Proposal for the 1 series of amendments to UN Regulation No. 153 (Fuel system integrity and electric power train safety at rear-end collision)

Submitted by the expert from France

The text reproduced below was prepared by the expert from France. The proposal aims to update the requirements on post-crash electrical safety of UN Regulation No. 153. The modifications to the current text of the UN Regulation are marked in bold for new or strikethrough for deleted characters.

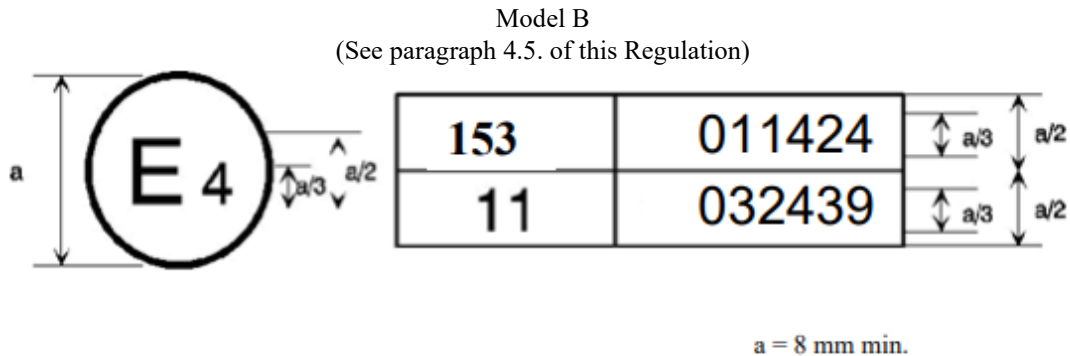
The above approval mark affixed to a vehicle shows that the vehicle type concerned has, with regard to the protection of the occupants in the event of a frontal collision, been approved in the Netherlands (E 4) pursuant to UN Regulation No. 153 under approval number 001424. The approval number indicates that the approval was granted in accordance with the requirements of UN Regulation No. 153 **as amended by the 01 series of amendments.**

The first two digits of the approval numbers indicate that, at the dates when the respective approvals were granted, UN Regulation No. 153 **incorporated the 01 series of amendments** and UN Regulation No. 11 incorporated the 03 series of amendments “

Figure 3
Jointed Test Finger

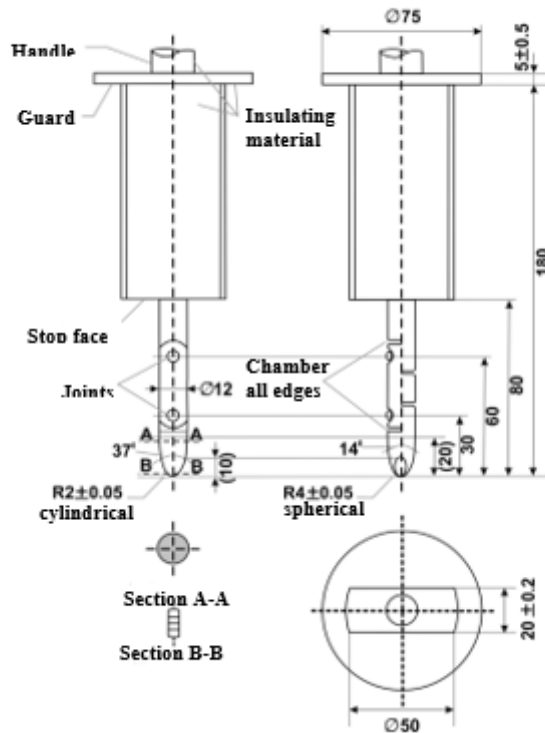
“4. Physical protection

Following the vehicle impact test any parts surrounding the high voltage components shall be, without the use of tools, opened, disassembled or removed. All remaining surrounding parts shall be considered part of the physical protection. The jointed test finger described in Figure 3 shall be inserted into any gaps or openings of the physical protection with a test force of $10\text{ N} \pm 10\text{ per cent}$ for electrical safety assessment. If partial or full penetration into the physical protection by the jointed test finger occurs, the jointed test finger shall be placed in every position as specified below.

Starting from the straight position, both joints of the test finger shall be rotated progressively through an angle of up to 90° **degree** with respect to the axis of the adjoining section of the finger and shall be placed in every possible position. Internal electrical protection barriers are considered part of the enclosure.

Tolerances on dimensions without specific tolerance:

(a) \ominus on angles: $+0/-10$ seconds $0^{\circ}0'0''/0^{\circ}0'10''$;

(b) \ominus on linear dimensions:

(i) **up to** ≤ 25 mm: $+0/-0.05$ mm;

(ii) **over** > 25 mm: ± 0.2 mm.

Both joints shall permit movement in the same plane and the same direction through an angle of 90° with a 0 to $+10^{\circ}$ tolerance.

The requirements of paragraph 5.2.2.1.3. of this Regulation are met if the jointed test finger described in Figure 3, is unable to contact high voltage live parts.

If necessary, a mirror or a fiberscope may be used **in order** to inspect whether the jointed test finger touches the high voltage buses.
